Trash Return Chutes

WN-0106

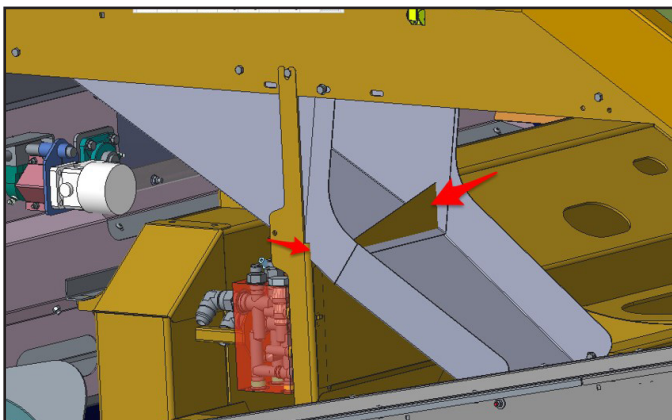
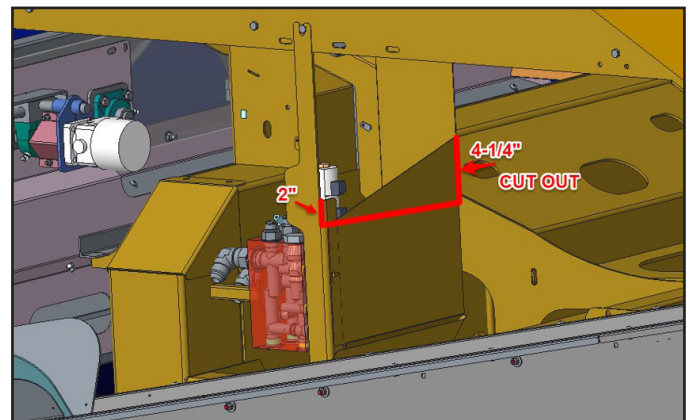
Introduced with the new Oxbo 6230, these new trash return chutes better return grapes and clusters to the bucket conveyance system. The steeper angle allows matter carried over by the bucket line to return to the bottom of the harvester. The new design provides better product flow in both grapes and olives.

The left side can be installed as a direct replacement for the existing trash chute. The right side requires modification. The machine shielding must be trimmed to accommodate the new chute as illustrated in the following pictures:
